20-1023
March 15, 2022

**Re: Draft Plan of Subdivision – 152 Main Street North, Grand Valley
1st Response to Functional Servicing Report Peer Review Comments
In Support of Draft Plan Application 300052619.000**

WESTVIEW TOWNHOUSES
RAINEY DRIVE, GRAND VALLEY

SERVICING PLAN / GRADING PLAN /
STORMWATER MANAGEMENT PLAN

Attached: revised Preliminary Stormwater Management / Grading /Servicing Plan – Drawing C1

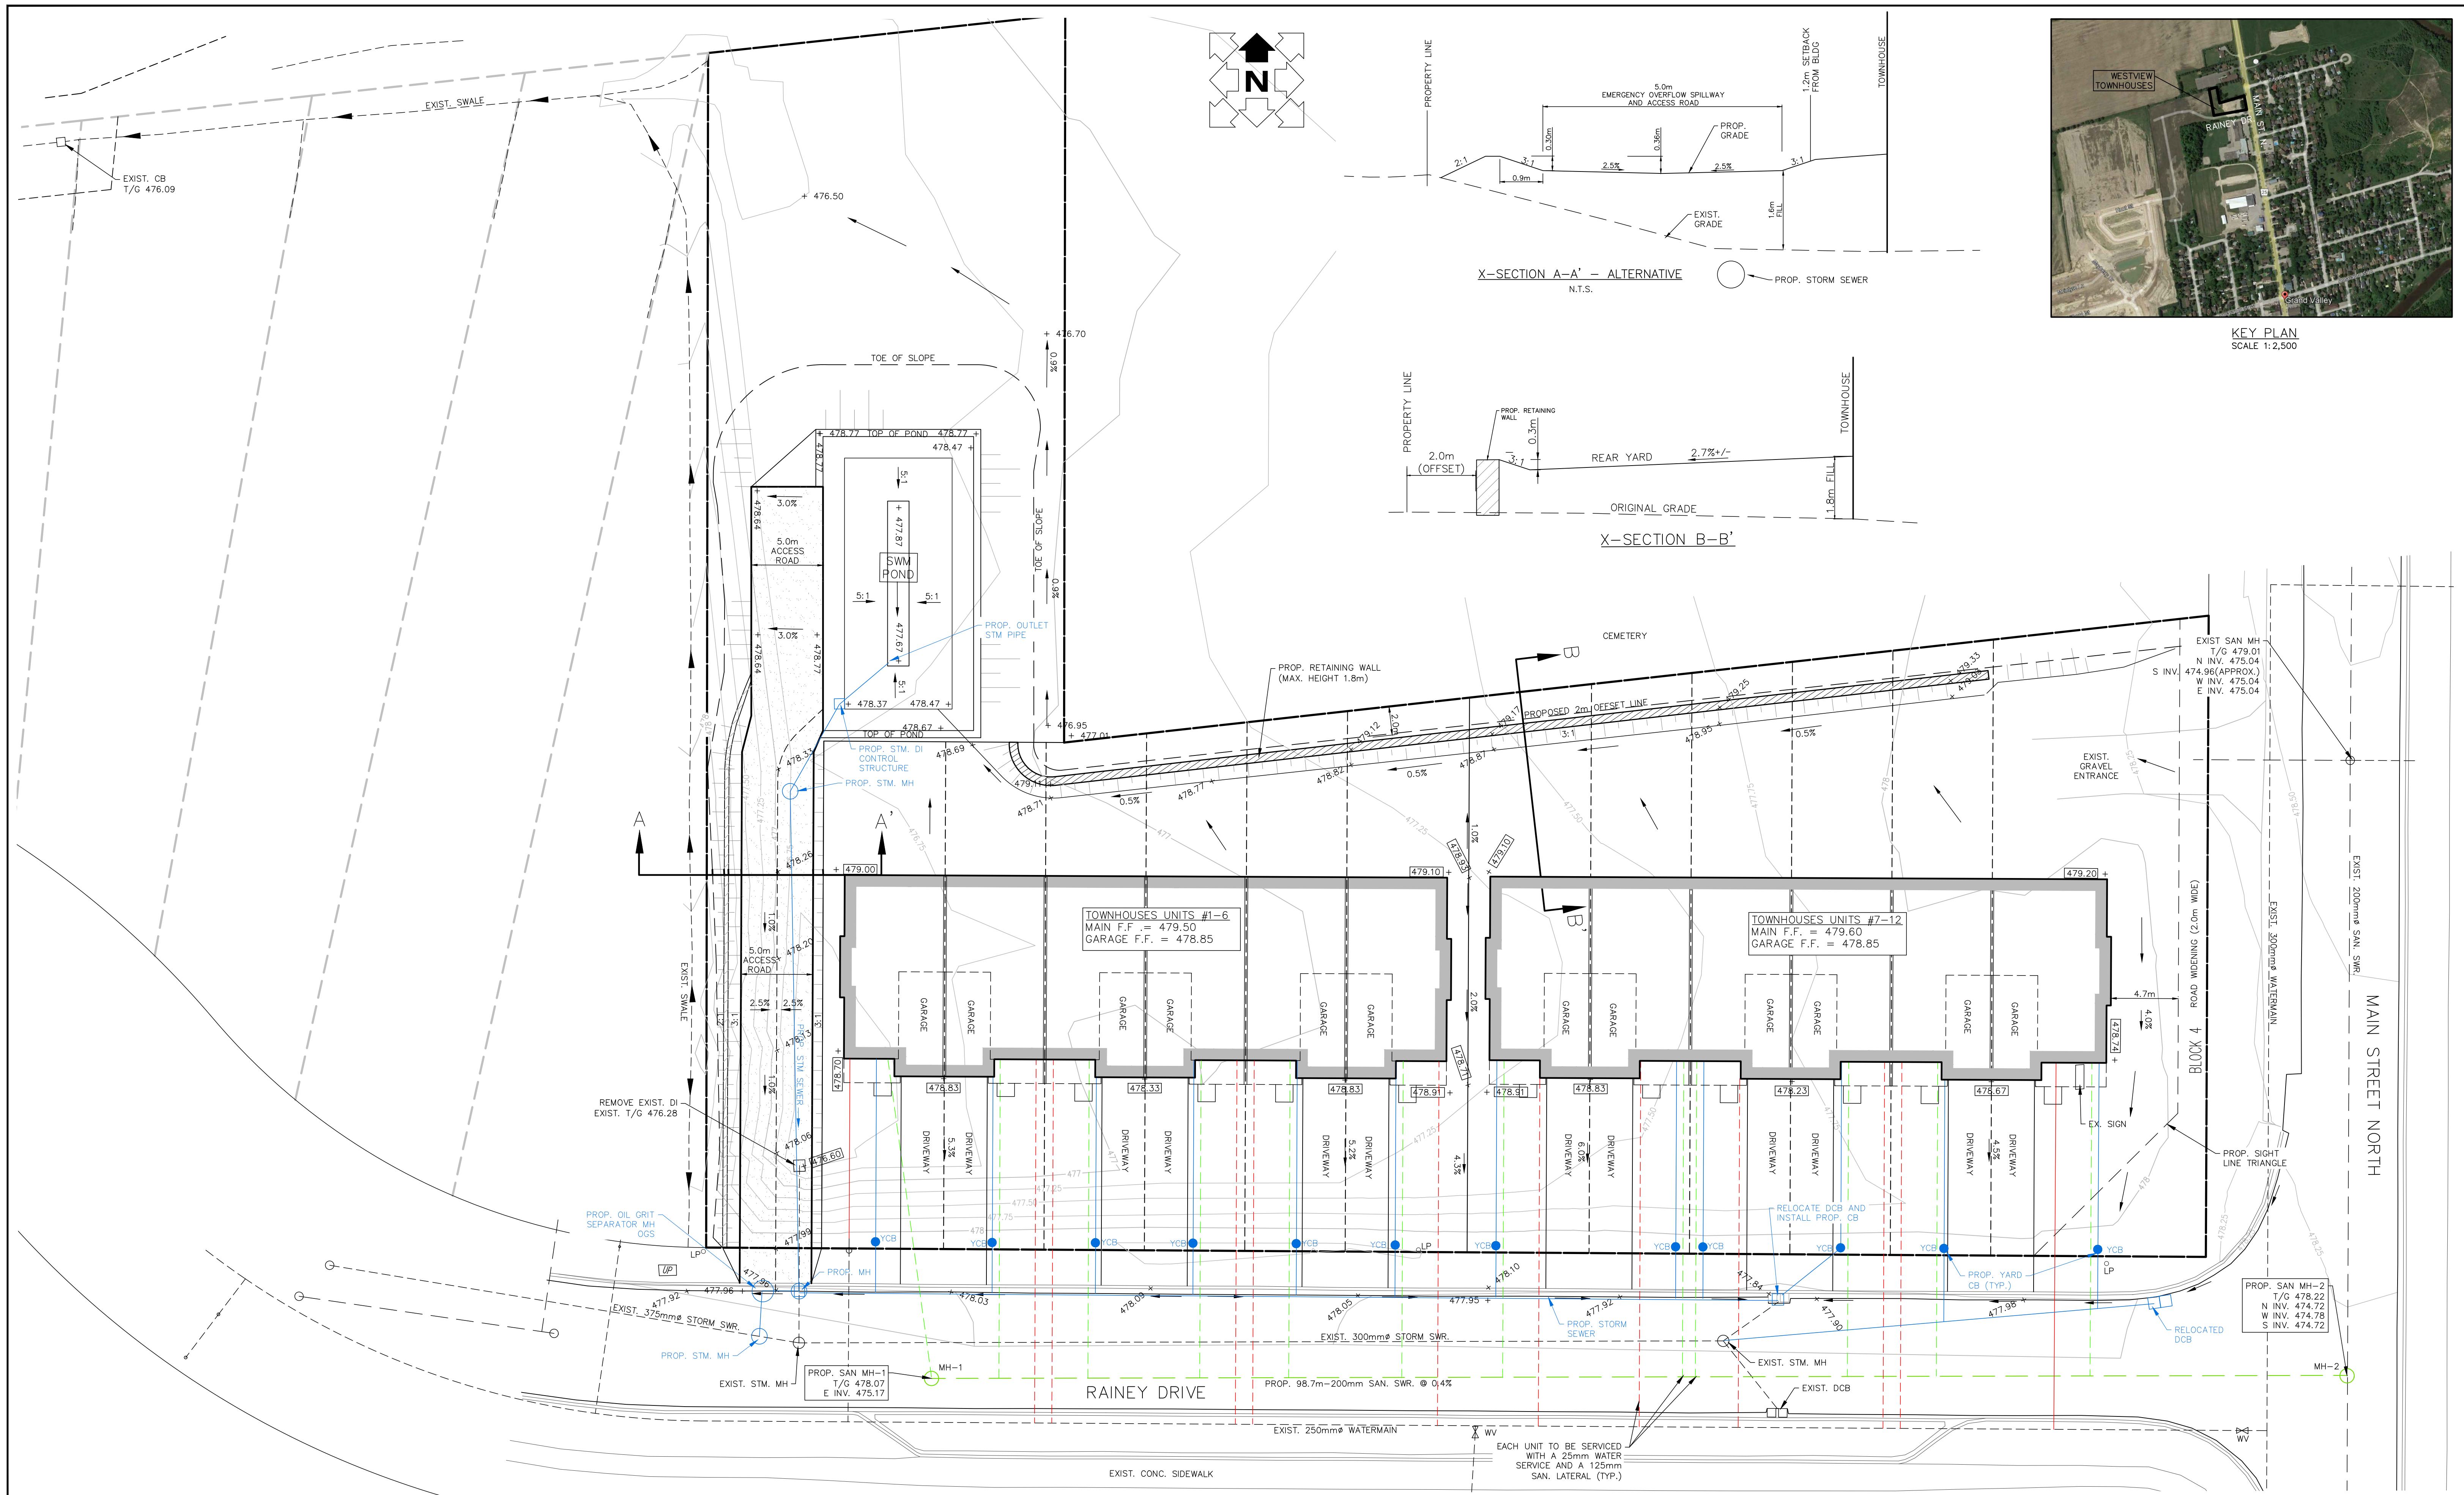
1. Acknowledge
2. Acknowledge – The Draft Plan has been revised accordingly and will be provided separately by GHD Planning.
3. Tulloch has had several discussions with Burnside on this point and we provide the attached updated preliminary stormwater management plan that should meet the necessary requirements. The retention swale "SWM Pond" has been moved to the back of the site below the cemetery lands and a 5m wide maintenance access has been sighted withing the proposed SWM block along the west side of the Townhouses that will terminate along the west side of the SWM Pond at the rear of the property. Considering that the SWM Pond will be shallow having mowable slopes and will not be designed to collect sediment, Tulloch sees no need to have the access road circumference the entire top of the facility. We trust that the current configuration demonstrated on the updated preliminary Stormwater Management Plan will be satisfactory for approval of the draft

- b) Acknowledged – final design of sanitary sewer will account for this Town standard
 - c) Acknowledged – a rear yard swale has been removed in favor of providing a retaining wall acting as a berm along the north property boundary as demonstrated on the attached preliminary grading plan. In any event the length of the flow route along the base of the rear yard grading at the face of the retaining wall will be less than 75 metres, which agrees with the Town standard.

6. Tulloch proposes to slope the Townhouse driveways to the curb line, removing the front yard swale. In addition, Tulloch proposes to collect runoff from the driveways in a separate storm sewer running east-west along the curb line /street line to collect runoff from the front yards and direct it to the OGS manhole for quality control purposes. Subject to the Town's acceptance of preliminary design demonstrated on the attached grading plan, Tulloch will complete a final design for approval by the Town and MECP.
